# UNITED STATES PATENT AND TRADEMARK OFFICE

| APPLICATION NO.  | FILING DATE | FIRST NAMED INVENTOR | ATTORNEY DOCKET NO. | CONFIRMATION NO. |
|--|-------------|----------------------|---------------------|------------------|
| 10/584,276   | 05/21/2007  | Robert Cudini        | CUDI3001 /EJD       | 4085             |

### Office Action Summary

### **DETAILED ACTION**

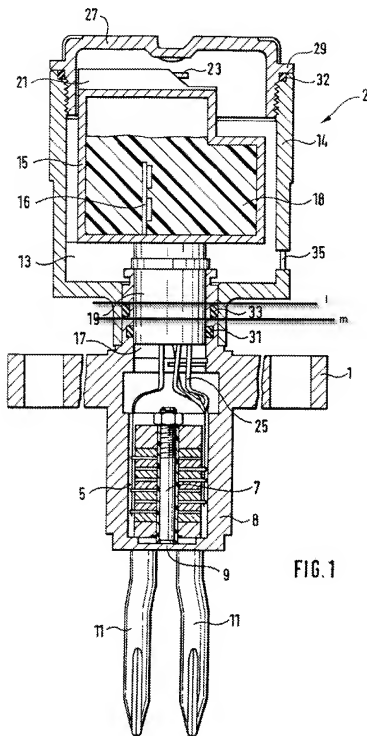
With respect to claim 28, Dreyer discloses the measuring device as claimed in claim 25 wherein: said seal [33] has on its outside, contacting the side wall of said connecting compartment, two sealing lips extending essentially in parallel with one another (see annotated Dreyer's figure 1 below).

With respect to claim 29, Dreyer discloses the measuring device as claimed in claim 27 wherein: said seal [33] is so arranged in said connecting compartment that the two sealing lips extend essentially in parallel with said gap in the side wall of said connecting compartment (see annotated Dreyer's figure 1 below and column 3, lines 52-61).

With respect to claim 30, Dreyer discloses the measuring device as claimed in claim 29 wherein: said seal [33] is so arranged in said connecting compartment that said gap in the side wall of said connecting compartment extends essentially between the sealing lips of the seal (see annotated Dreyer's figure 1 below and column 3, lines 52-61).

Note sealing lips touching lines l and m are parallel.

FIG. 1

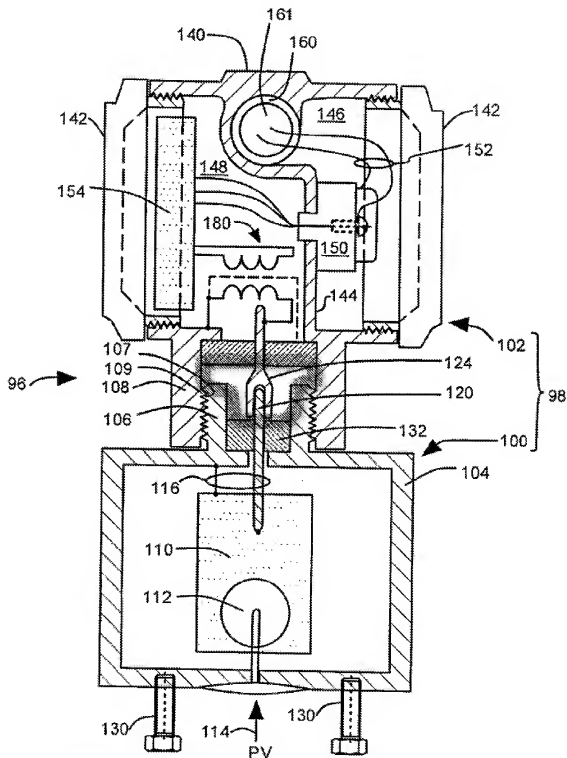
With respect to claim 20, the combination of Dreyer and Frick disclose all the claimed limitations of claim 18 above and also disclose that at least one of said two connecting elements has electrically conductive, plug elements (Frick, element 124 of figure 1) directed essentially in parallel with one another (see Frick, Figure 1); and the other of said two connecting elements has electrically conductive, socket elements (Frick, element 120 of figure 1) directed essentially in parallel with one another and corresponding to said plug elements; said plug elements are inserted into said socket elements and so contact said socket elements, that said sensor and said measuring device electronics are electrically connected together (see Frick, paragraph 29); and said plug elements and said socket elements are directed essentially in parallel with said at least one groove of said connecting compartment and/or with the at least one projection of said connecting compartment (see Frick's figure 1).

With respect to claim 21, the combination of Dreyer and Frick disclose all the claimed limitations of claim 20 above and also disclose that both said plug elements and said socket elements protrude into said connecting compartment (see annotated figure 1 of Frick below).

Note the highlighted connecting  
compartment region in which both 120 and  
124 protrude into.
